IEC 63171-1 Connector Standard progresses to FDIS

IEEE 802.3cg Task Force

August 2019 interim

IEC 63171-1 ED1: CONNECTORS FOR ELECTRICAL AND ELECTRONIC COMPONENTS – PRODUCT REQUIREMENTS – Part 1: Detail specification for 2-way, shielded or unshielded, free and fixed connectors: mechanical mating information, pin assignment and additional requirements for TYPE 1 / Copper LC Style

Examples of dimension changes

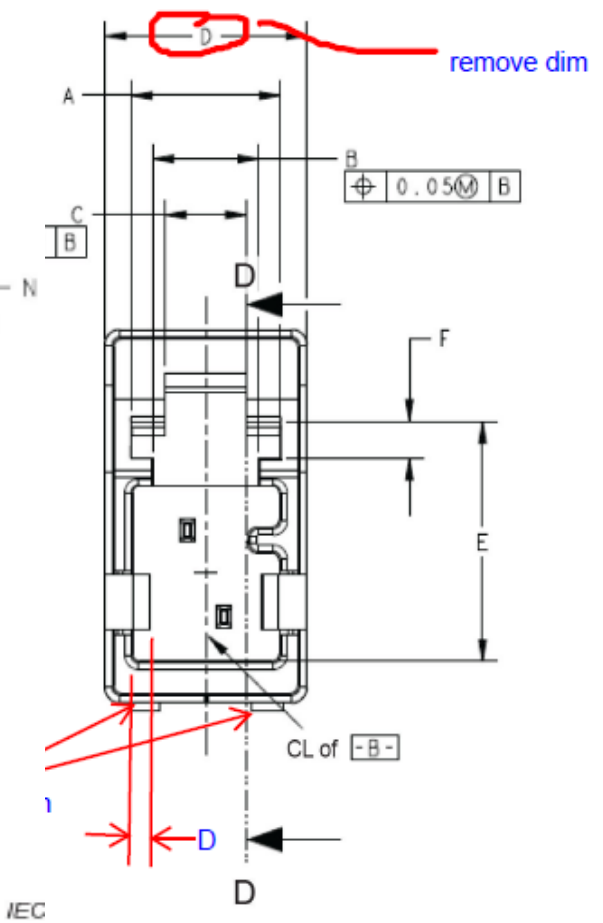
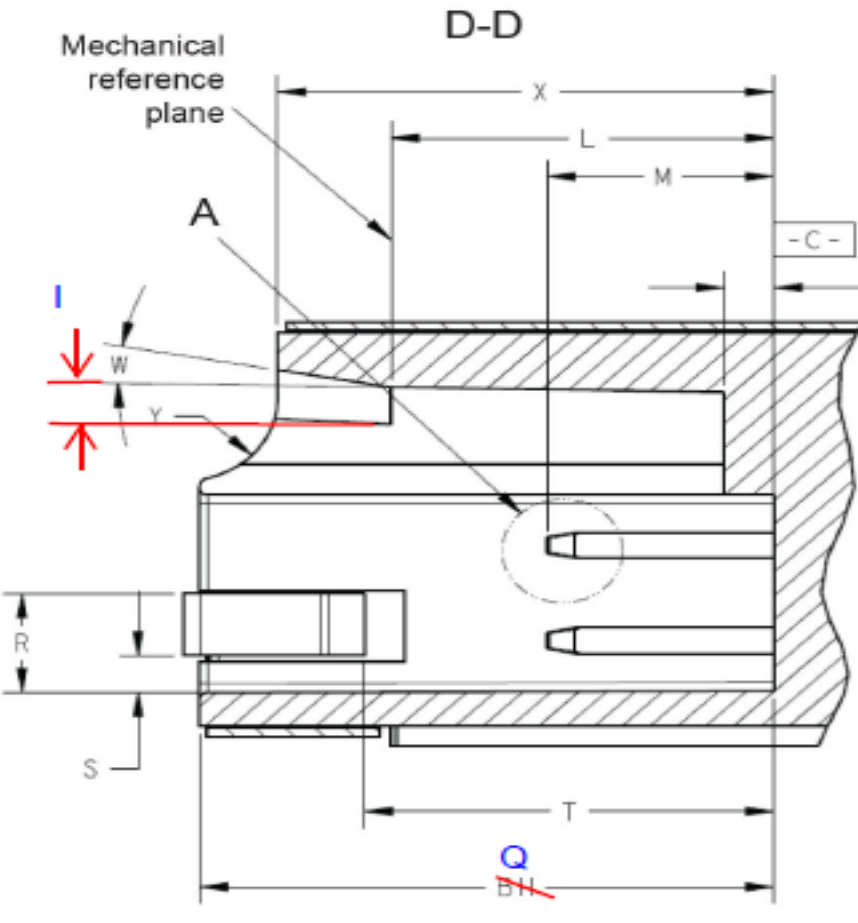
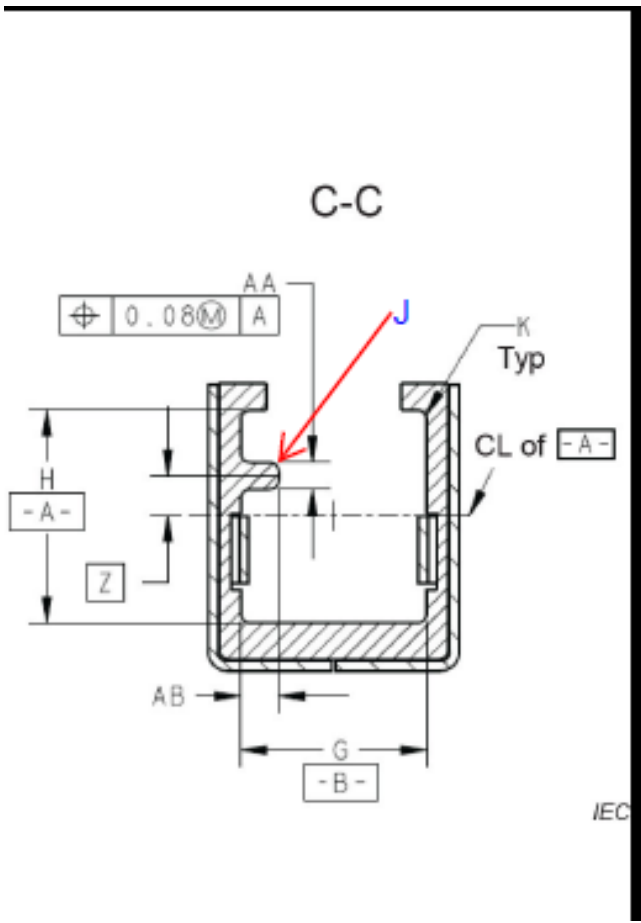
- Unnecessary legacy dimensions eliminated to allow design innovation and some dimensions adjusted for completion/consistency/accuracy (NO)
- Current capacity increased from 1.4 A per contact to 2.0 A per contact at 60 C (YES)
